BID ADDENDUM NO. 02

Project: SKUSD- Tropico Middle School Expansion Project
(**Project Number:** SKUSD-TMS-EP)

CHANGES TO ADDENDUM NO.2

1. See Attached Bid Clarification 01 documents (issued by Flewelling & Moody dated Feb 07, 2022)

**BUILDING 'A'
CLASSROOM FLOOR PLAN**
SCALE: 1/8" = 1'-0"

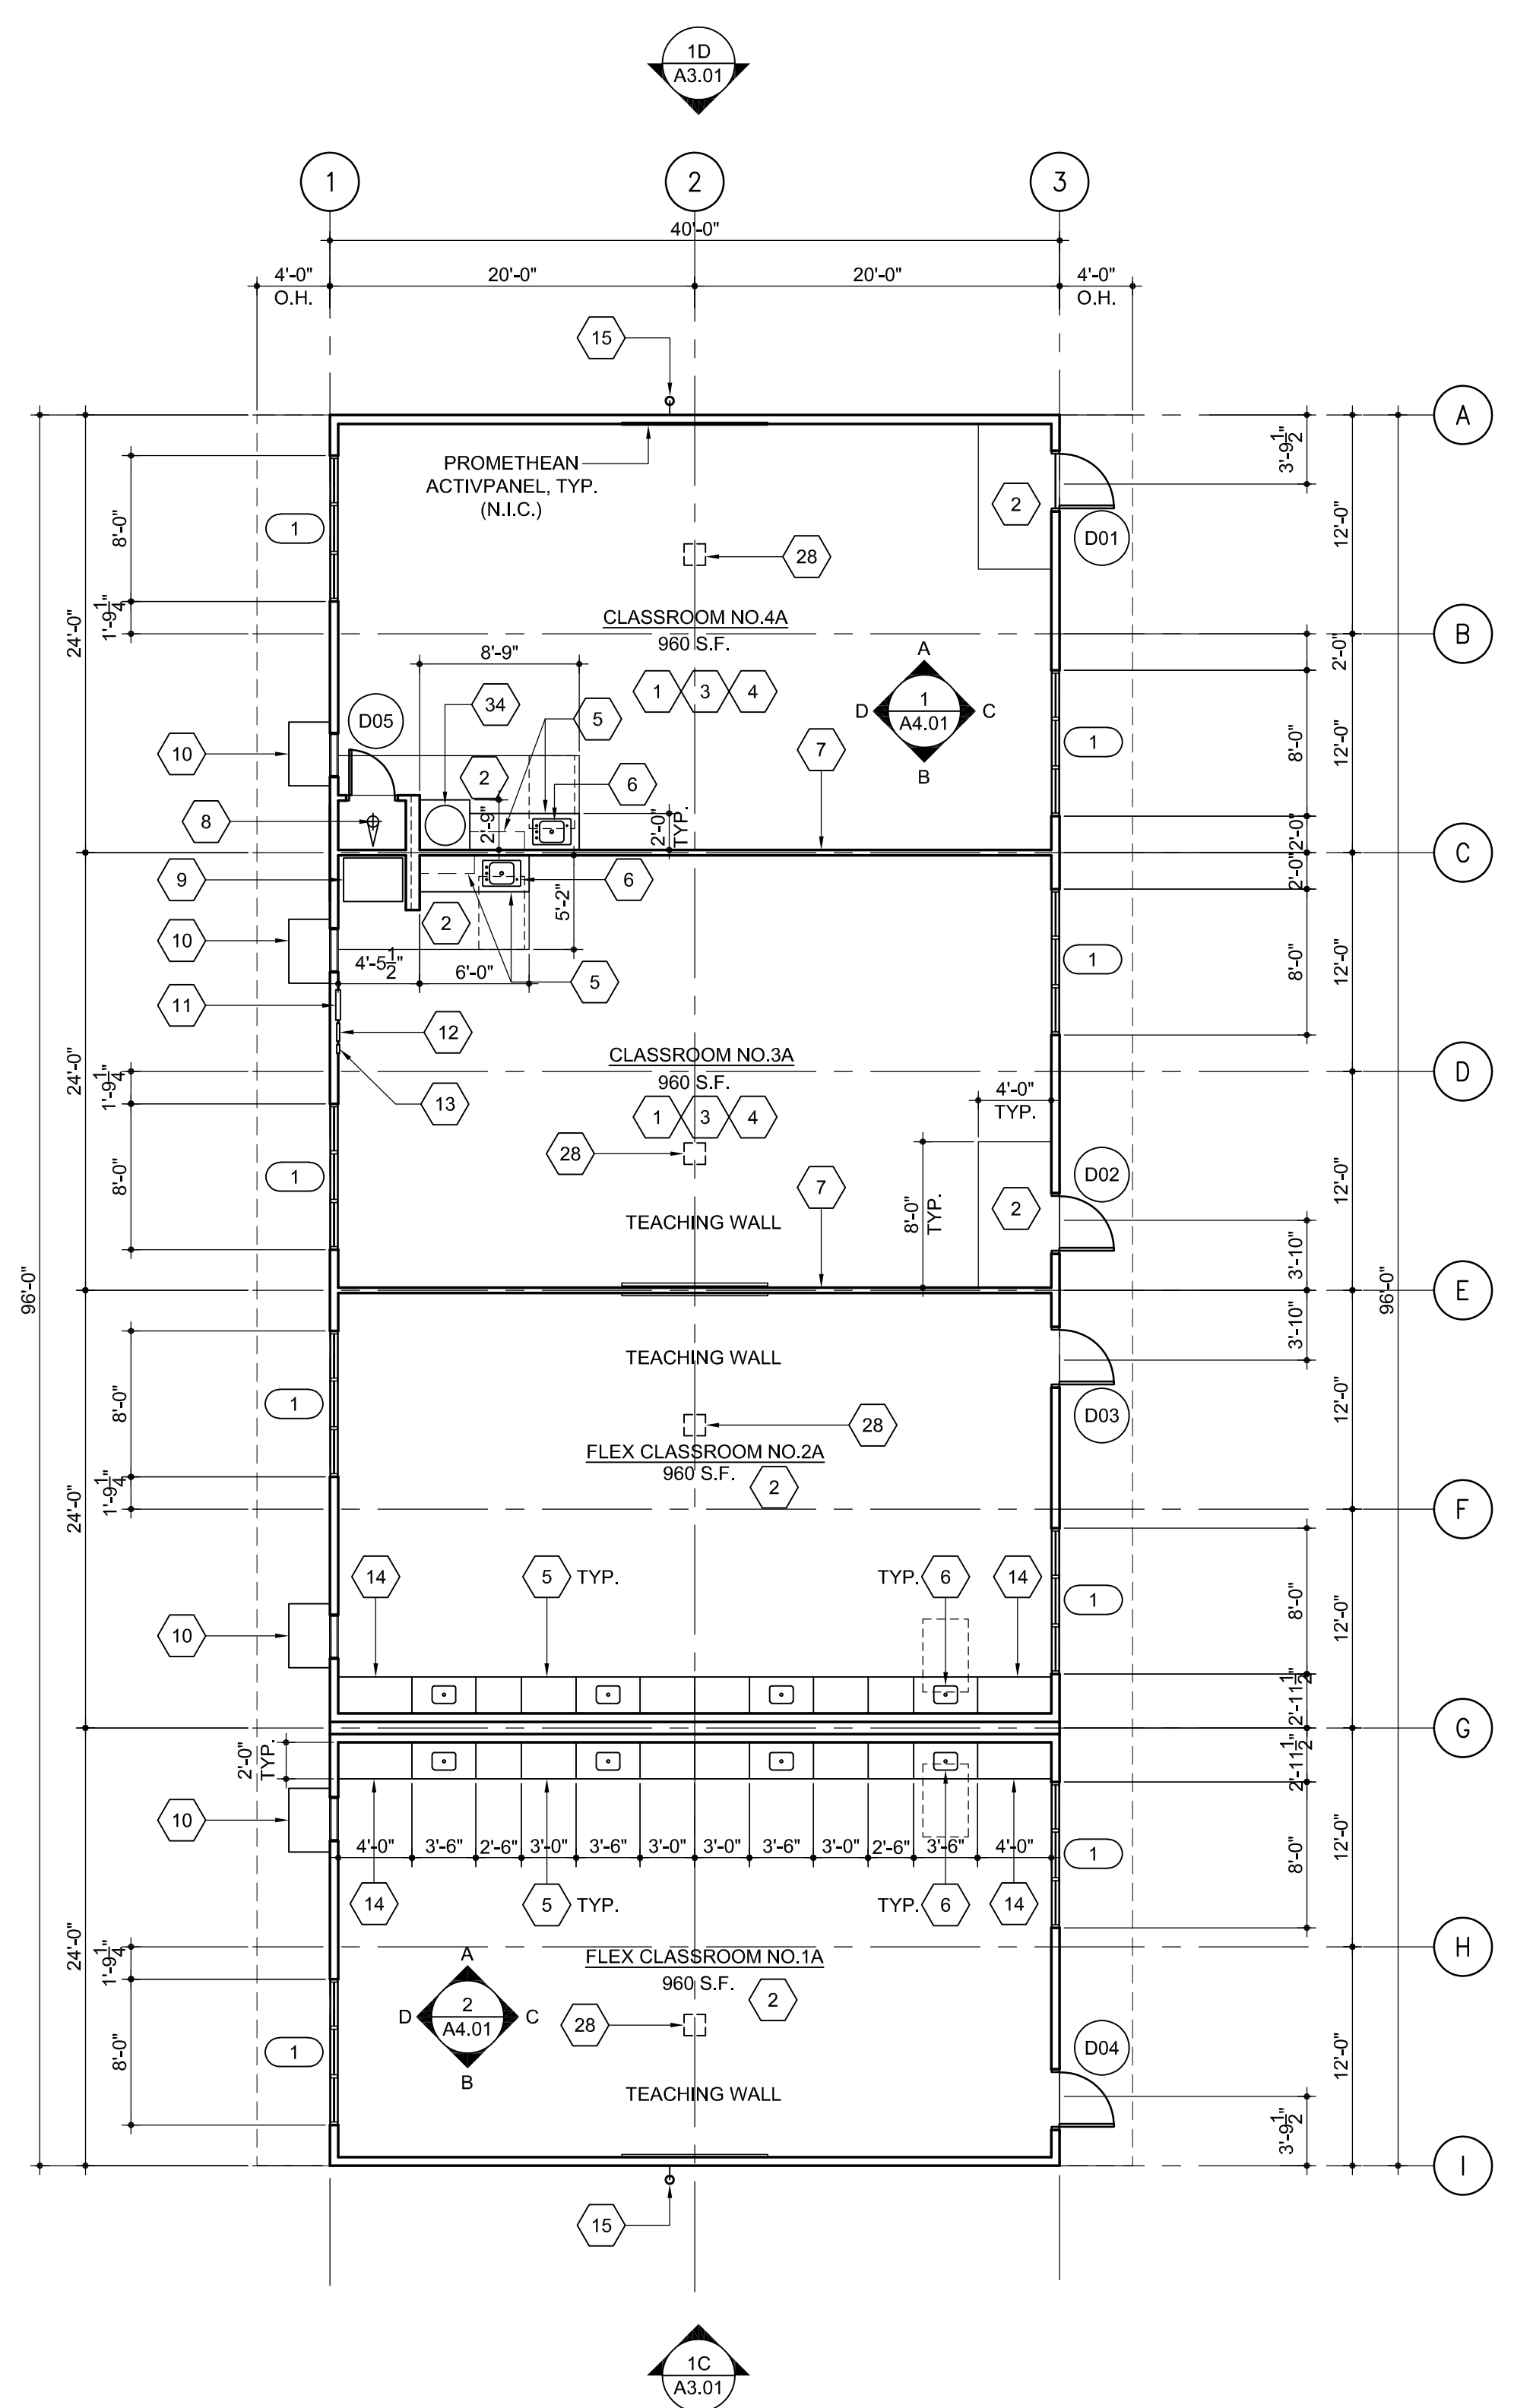
The drawings throughout but for example on A2.01, note 29 calls for a hi-lo drinking fountain, however, drinking fountain location(s) doesn't appear to be shown on the floor plans or elevations. Can you please confirm whether a drinking fountain is required and provide location(s).

Hot water will be required, see revised sheets A2.01, A2.02, A2.03, A2.04, A2.05, A2.06 and keynote no. 33, 34 & 35 (Bid Clarification No.1_02-08-2022)

Keynote #29 (Hi-Lo Drinking Fountain) is shown on Bldg. C (Det.1/A2.02) and Bldg. F (Det.2/A2.03). Delete all callouts '(P) D.F.' as noted on Site Plan, Det. 1/A1.02

TYP. CLASSROOM INTERIOR ELEVATIONS

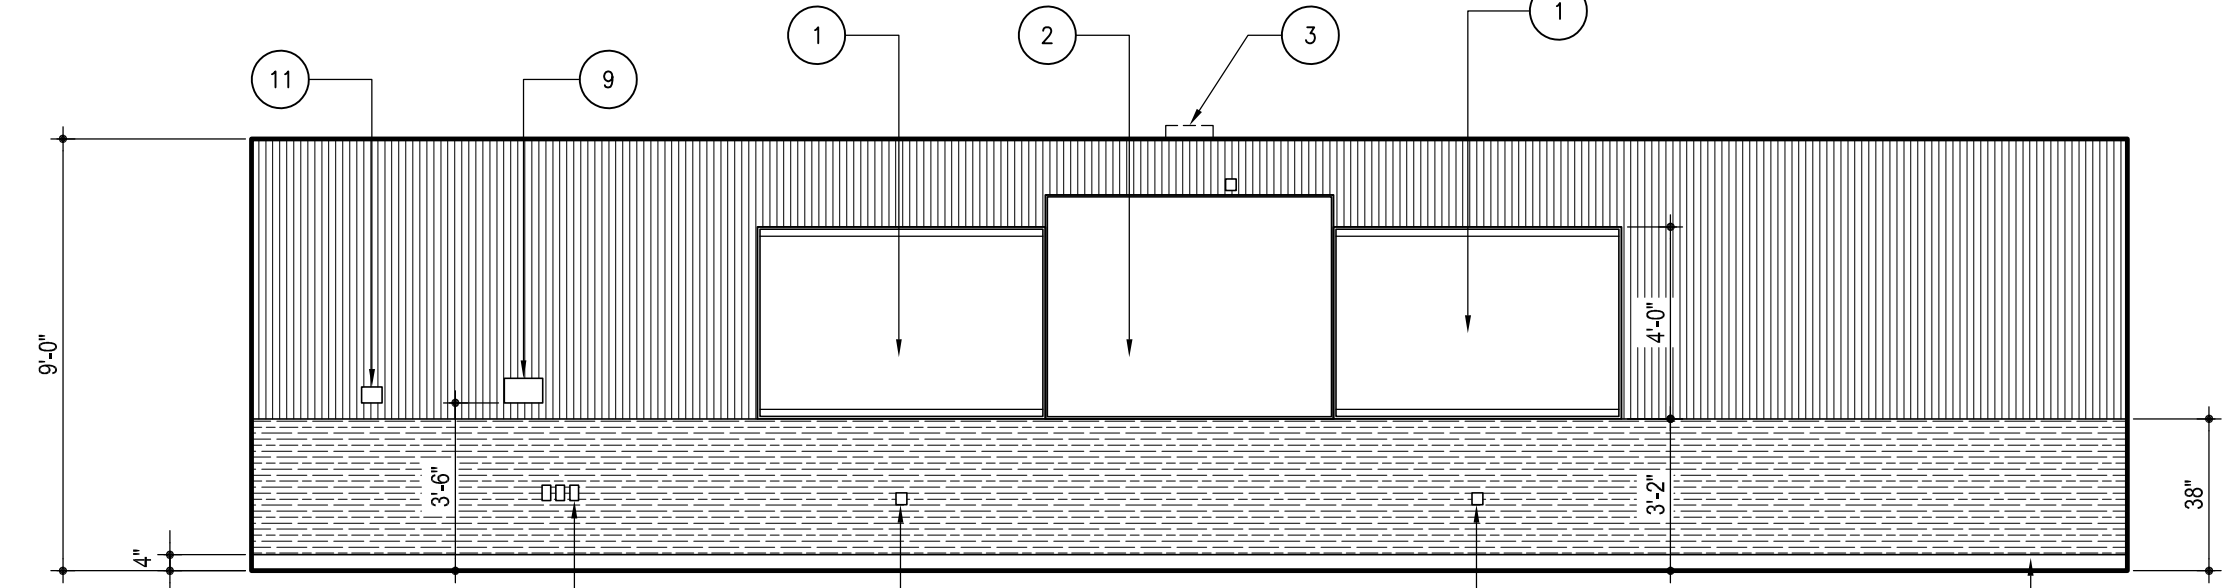
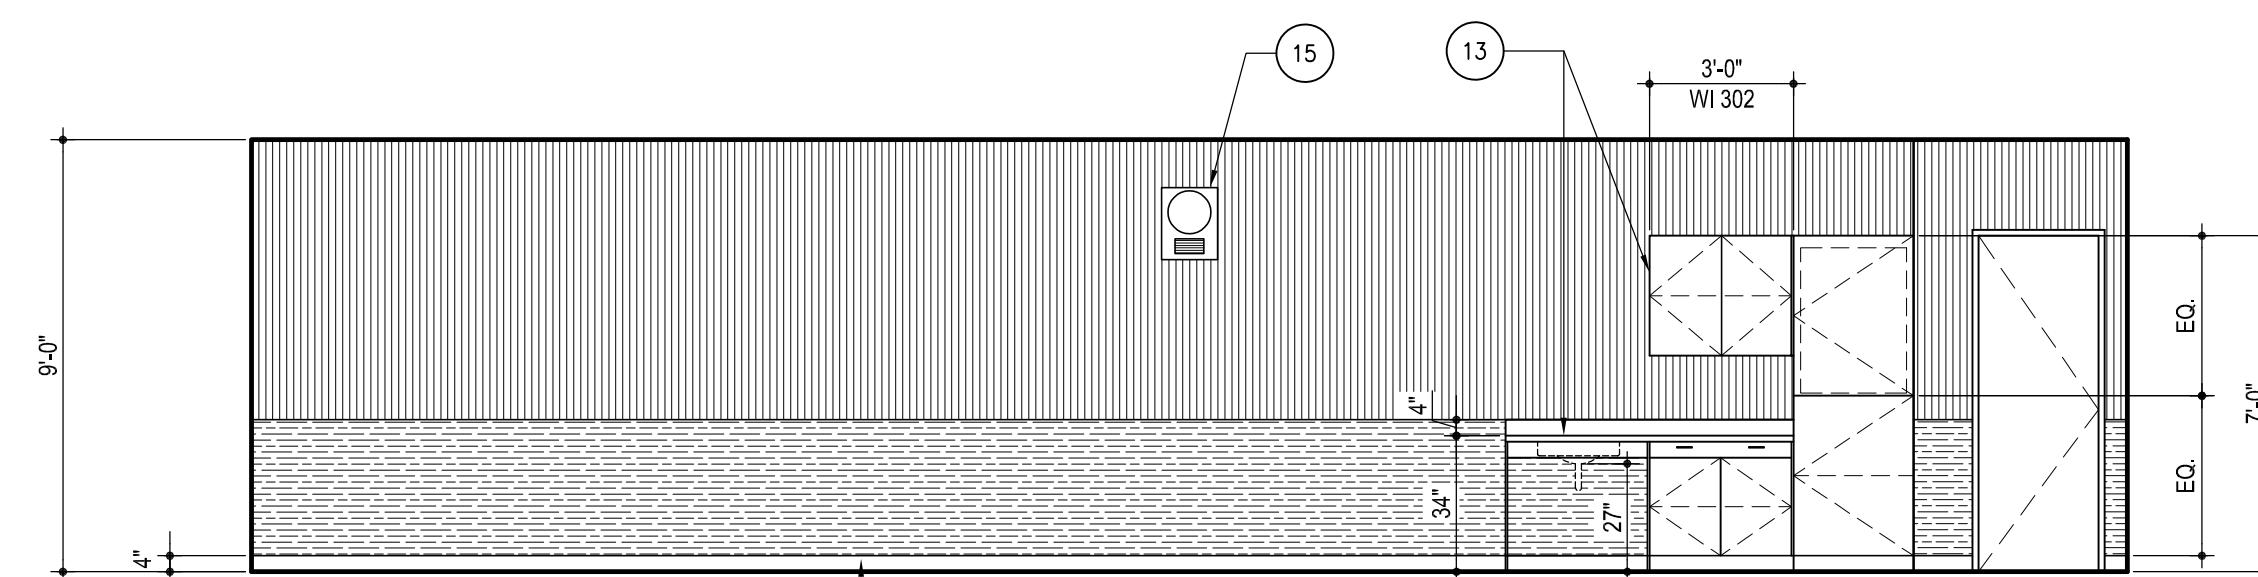
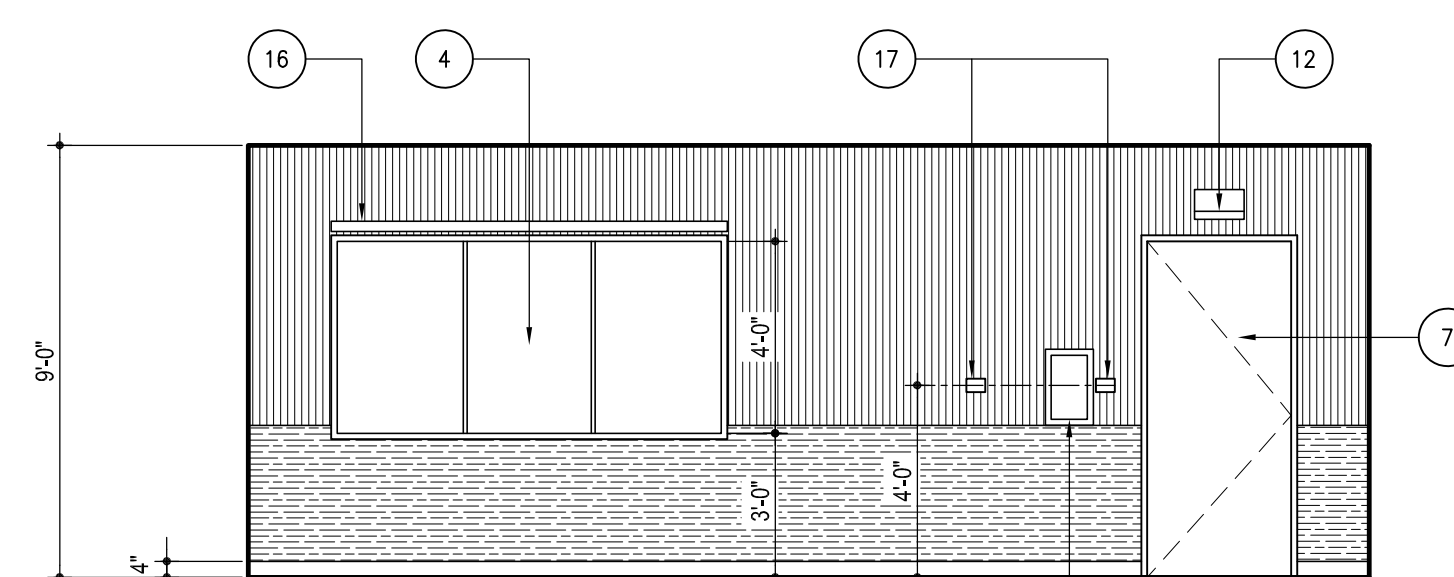
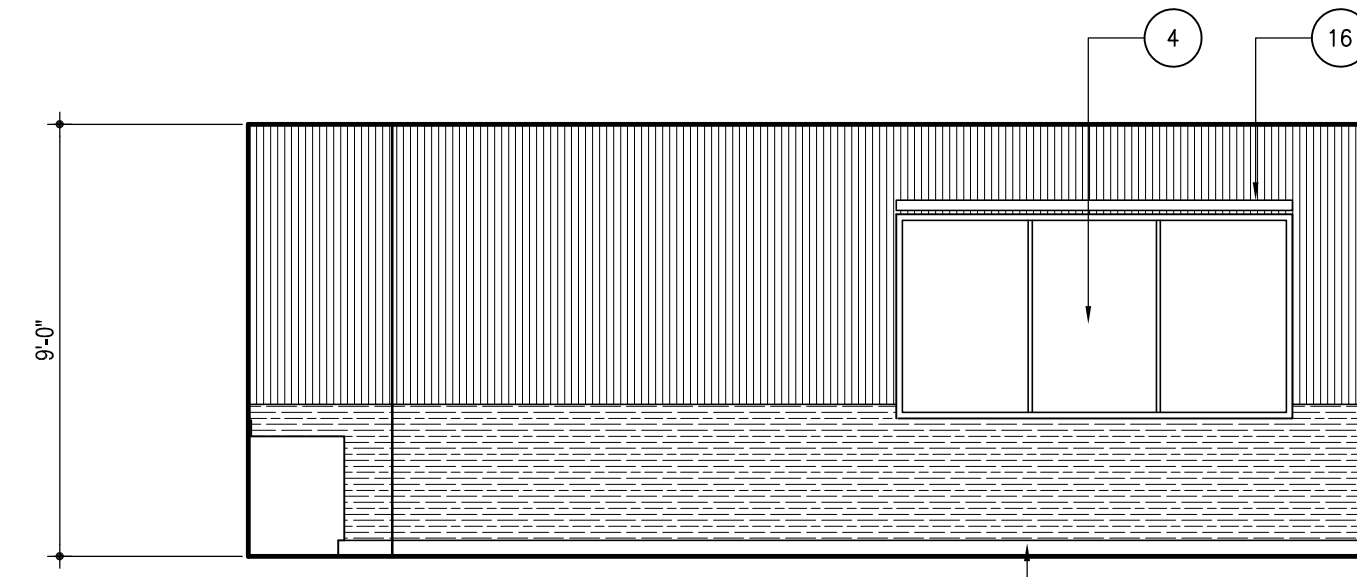
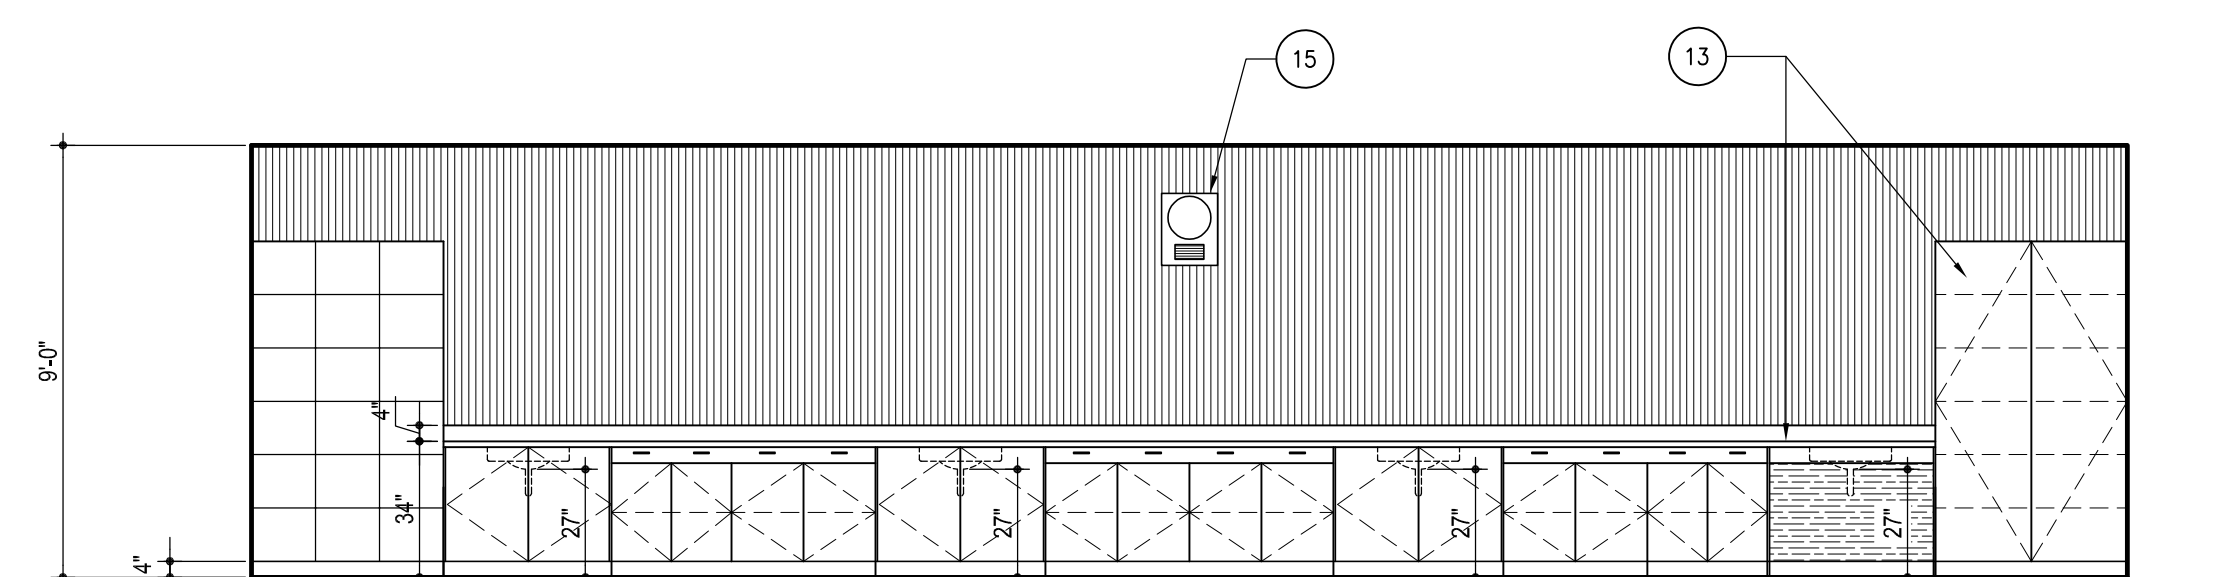
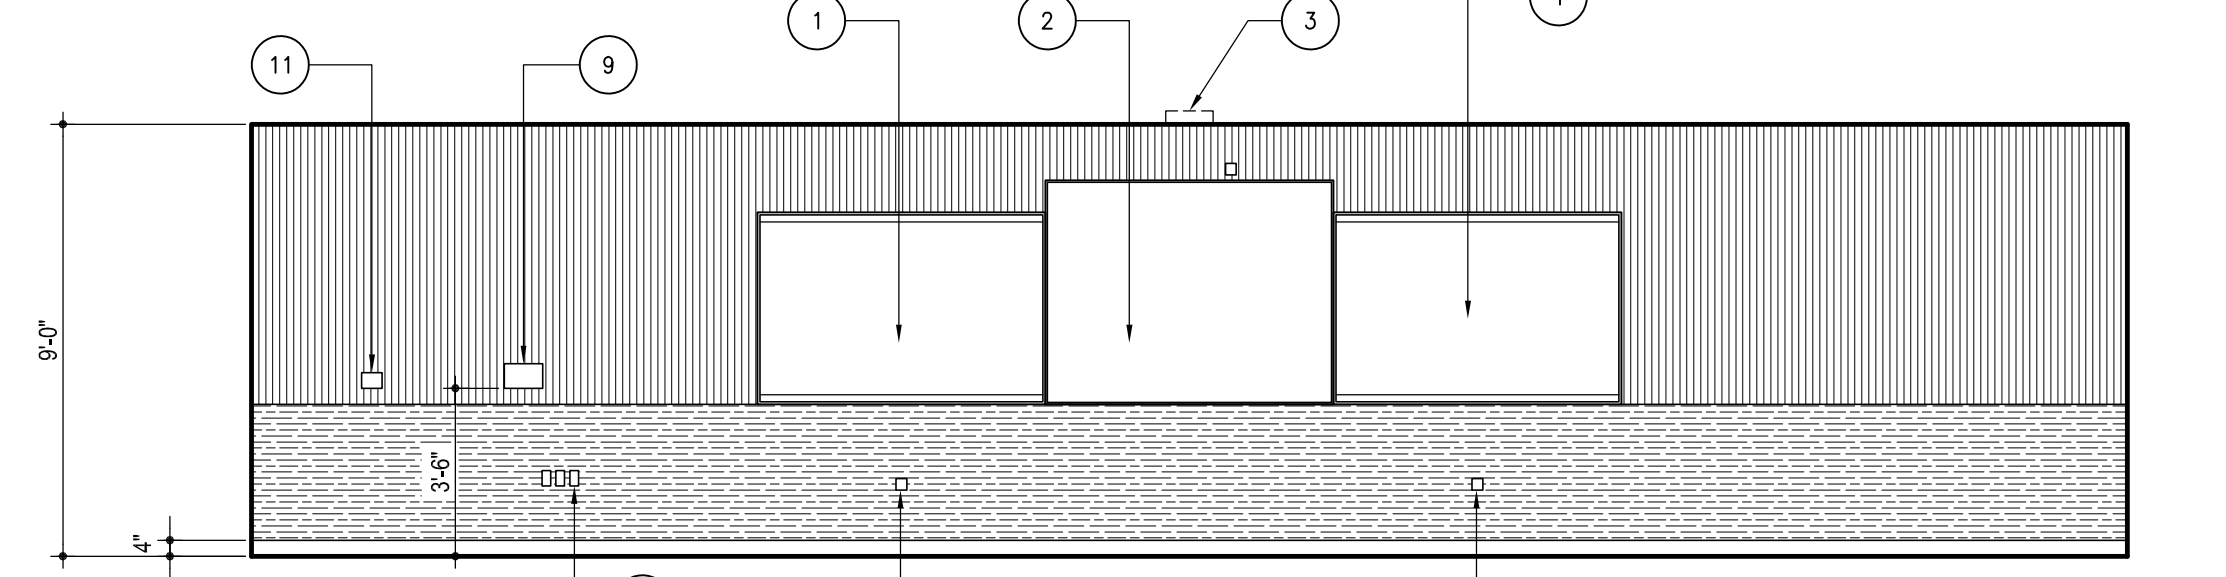
- a. The end of this note states "All file drawers use accommodate a standard pendaflex hanging file system....". None of the cabinets shown on the interior elevations on A4.01 show cabinets with drawers to support a hanging file system. Confirm whether this was an error and/or provide WI# associated with this cabinet as well as its location(s).
- b. For the typical flex classroom casework elevations, many of the cabinets appear to be WI222, however, the info is not provided. Please confirm.
- c. For the typical flex classroom casework elevations, provide WI# for the 2 tall cabinets.
- d. Confirm if WI cert is required.
- e. Confirm that there will only be 1 upper cabinet as shown on interior elevations, per A4.01.

Drawing A4.01, Elevation-C shows a door with a view lite, however, the exterior elevations do not show doors with view lites, nor does there appear to be any call outs for it. Please confirm whether exterior doors are to have view lites.

- A. Delete the statement ' All file drawers must accommodate a standard pendaflex hanging file system'.
- B. See revised interior Elevation-A, Det. 2/A4.01 & Elevation B, Det. 1/A4.01 (Bid Clarification no.1_02-07-2022)
- C. See revised interior Elevation-A, Det. 2/A4.01 (Bid Clarification No.1_02-07-2022)
- D. Yes, WI cert will be required
- E. Yes, there is only (1) upper cabinet as shown on Elevation B/Det. 1/A4.01 (Bid Clarification No.1_02-07-2022)
